#### Reserve Business Center, Preliminary Plan, 120130100

Staff Recommendation: Approval of Preliminary Plan 120130100 and associated Preliminary Forest Conservation Plan (PFCP) and tree variance with conditions.

Figure 1. Specimen trees with critical root zones circled in blue that are located along the western boundary of the subject site.

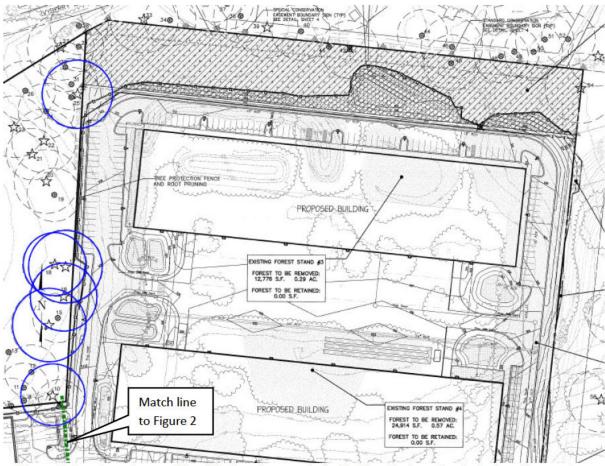
The Applicant is proposing to impact the critical root zones of six specimen trees located off-site to the west of the property. In the event the proposed limits of disturbance necessitates the removal of any of these trees, the Applicant would be required to obtain permission from the landowner and to obtain a new variance approval from the Planning Department prior to any tree removal.

Figure 2. Specimen trees (#61-63, 68) proposed for removal as indicated with red Xs.

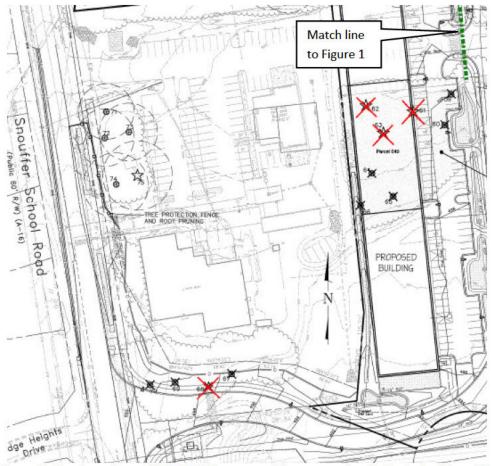
The Applicant submitted a variance request on April 2, 2013 for the impacts to and removal of specimen trees as depicted on the attached PFCP (Attachment 7). The Applicant is requesting a variance to remove four specimen trees (trees >30" DBH) and to impact the critical root zones of six specimen trees that are considered high priority for retention under Section 22A-12(b) (3) of the County Forest Conservation Law. These 10 trees are further described in Tables 1 and 2, below.

The Applicant proposes to disturb the critical root zones of six specimen trees and to remove four specimen trees; three of which are located within an existing forest stand and will be mitigated for as part of the planting requirement. The remaining tree (#68) is to be removed in order to align the access driveway at Snouffer School Road with Ridge Heights Drive. In order to mitigate for the removal of this tree, the Applicant has proposed to plant three 3" caliper native trees on-site. This mitigation follows Staff's recommendation that replacement should occur at a ratio of approximately 1" caliper for every 4" DBH removed. While these trees will not be as large as the trees lost, they will provide some immediate canopy and will help augment the canopy coverage. Because these trees are in mitigation for specimen trees removed, they do not count toward afforestation requirements.

Staff recommends that the Planning Board approve the Preliminary Forest Conservation Plan with the conditions cited in this Staff Report. The Variance approval is assumed in the Planning Board's approval of the Preliminary Forest Conservation Plan.
